Rezoning Transportation Analysis

Petition Number: 2023-040

Date	Description
7-27-23	First Review (PDM)
03-20-24	Second Review (KC)

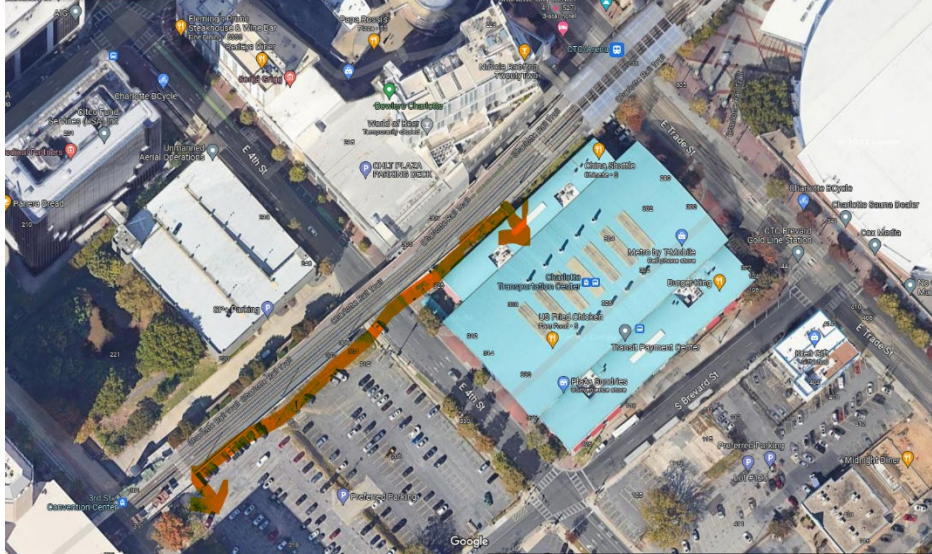
- Outstanding Comment 03-20-24:** Revise site plan and conditional notes to provide a 12ft rail trail along the Blue Line and provide a connection to the Rail Trail to the site that accounts for bicycle traffic within the design.

Clarifying Comment 03-20-24: Update and revise site plan to accommodate for the rail trail as shown below:
